SERVICE INFORMATION LETTER

SIL T-060 Revision 2 Page 1 of 7

1. SUBJECT: AeroLEDs Sunspot 36HX Landing Light Upgrade

2. MODEL: 480B

Figure 1. P/N 01-1030-H-A-P, Rev. C Landing Light

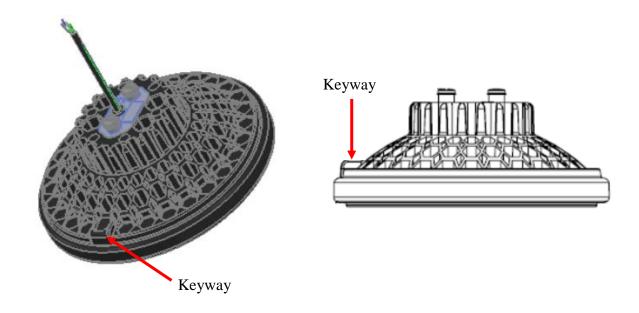
The Rev. C version of the landing light features a keyway (Figure 1) to ensure the light assembly is installed in the proper orientation. If upgrading from a Rev. A or Rev. B landing light assembly to a Rev. C version, the holder plate requires modification to fit the keyway.

The kit includes the landing light assembly, a wire assembly, and a holder assembly to complete the installation. The key characteristics of the new landing light version are a redesign of the electrical attachment to include screw terminals and a slight change in the size of the retention (holder) plate.

Figure 3. Wire labels

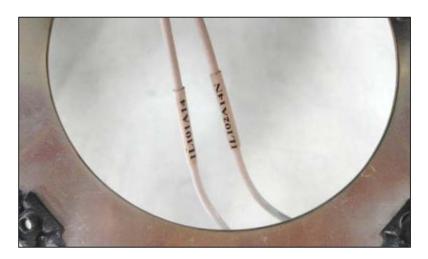
- 6.1.7 Install wire assembly (P/N 4230090-5).
 - 6.1.7.1 Ensure the YE, GR, and BL wires are wrapped with shrink tube (Figure 2).
 - 6.1.7.2 Ensure the wire ends are labeled on the 4230090-5 wire assembly with wire markers (1L101A14 and 1L102A14N) (Figure 3).

Figure 5. Notch Filed in Holder Plate

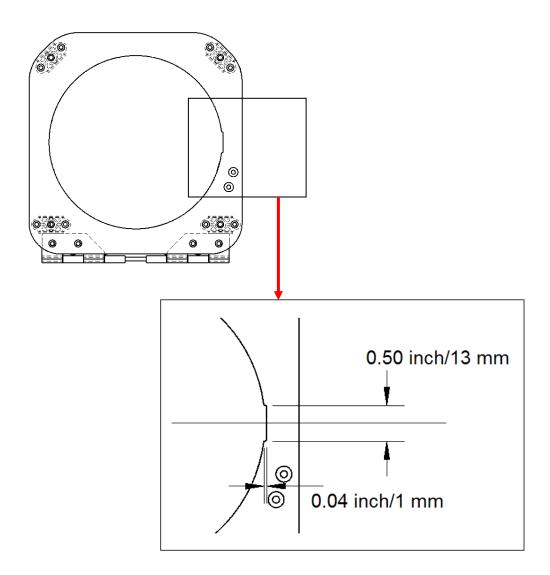
6.2.3 Modify the holder plate (P/N 4212103-33):

6.2.3.1 Using an appropriate size metal file, gently file a notch in the holder plate to the dimensions specified in Figure 5 to accommodate the keyway on the Rev. C assembly.
